Re: Standing Policy Committee on Planning and Urban Development (PUD)
PUD # 2021-0015

North Hill Communities – Local Area Plan – Final Proposed Plan

Standing Policy Committee on Planning and Urban
Development (PUD) reference # PUD2020-0164

RE: Proposed North Hill Communities Local Area Plan

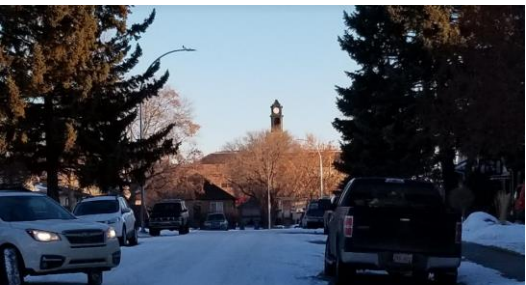
I am writing to voice my concerns regarding the proposed plan. As an advocate of making Calgary a great city, I participated in the engagement opportunities with The City regarding North Hill Communities local area plan with a specific interest in the Crescent Heights area. I am disheartened to see what has been agreed upon at the sessions changed that I participated in and my concerns have not been addressed by the plan. While believe that the plan is premature pending the resolution of the GreenLine, the focus of this letter is on the potential loss of character, lifestyle and sense of place in the historic areas of Crescent Heights.

Excerpt from:
MAP C:
Heritage
Planning Areas

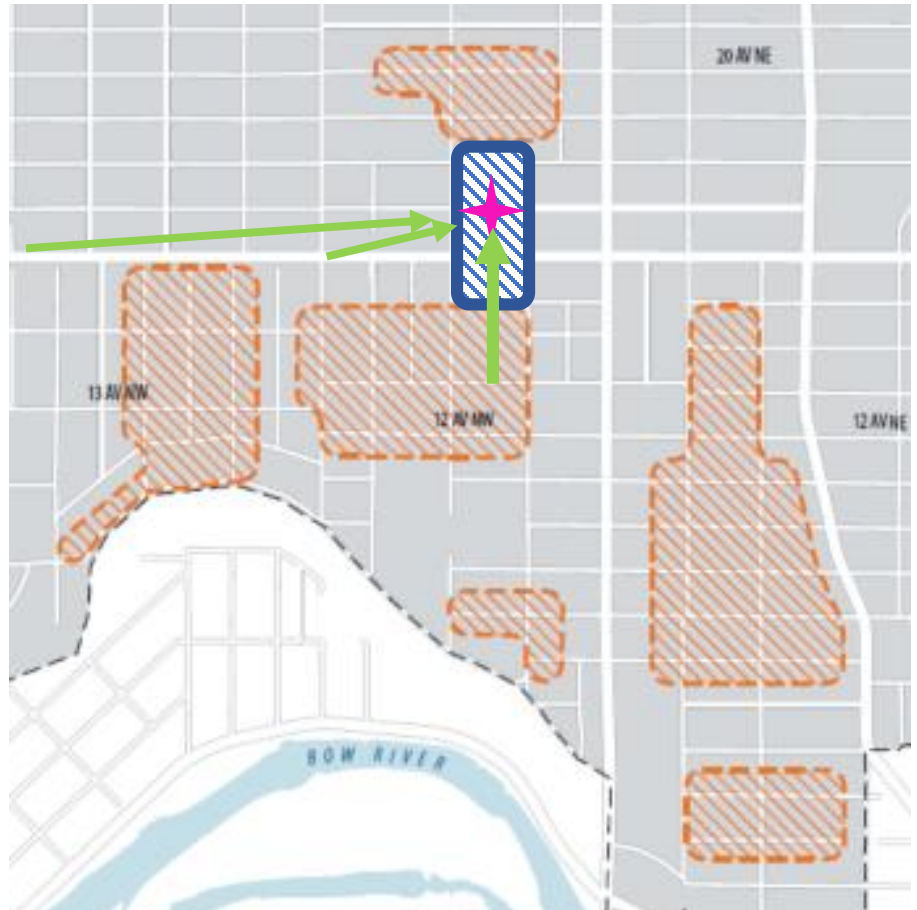
To address this concern, I respectfully request amendments to the plan in Chapters 1 and 2 to protect the view corridor down 1A ST W to Balmoral School. In addition, City Council may wish to have additional view corridors to the tower recognized such as views from key intersections along 16th Avenue such as those from 8th Street and 4th Street.

In addition, I request an amendment to the Heritage map in Appendix C of the plan to help ensure that views to this historic landmark are considered in future planning decisions.

-  View Corridor
-  Balmoral School clock tower
-  Area proposed to be included as a Heritage Planning Area to protect historic view corridor.

**MAP 3:
 Urban Form**

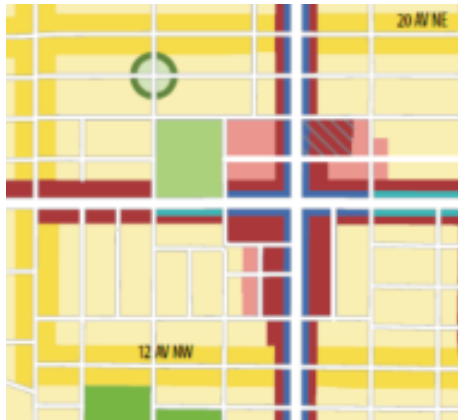
Increasing building heights along the north side of 15th Avenue should respect existing homes (many are single story post war homes) and the neighbourhood local urban form as shown in map 3 by having individual entrances to ground orientated units facing 15th Avenue.

**MAP 4:
 Building Scale**

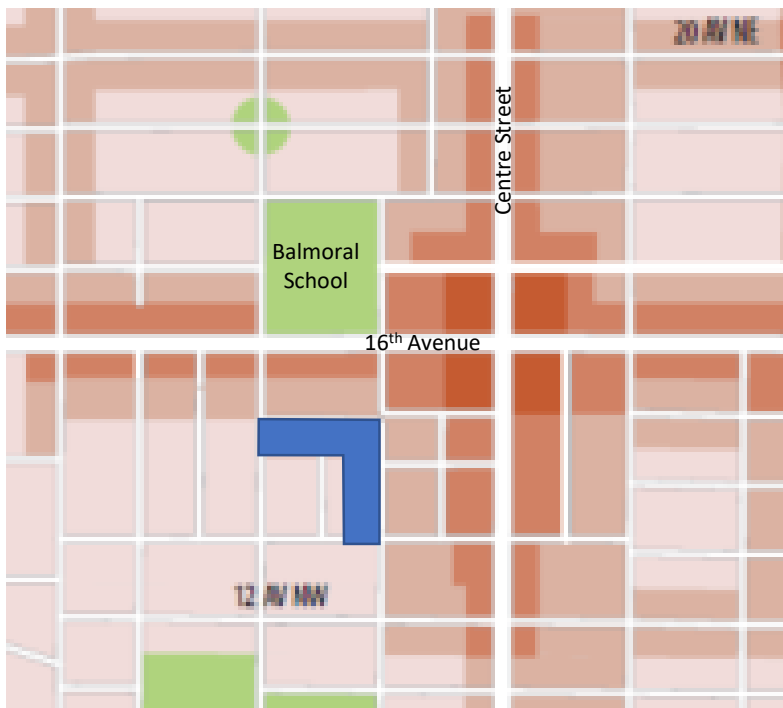
The change to the plan that I respectfully request is to amend Map 4: Building Scale to change the areas shown in blue on the bottom of this page from Low (up to 6 Storeys) to Limited (up to 3 Storeys).

Proposed amendment to Map 4

Request blue section to be classified as Limited (up to 3 Storeys)
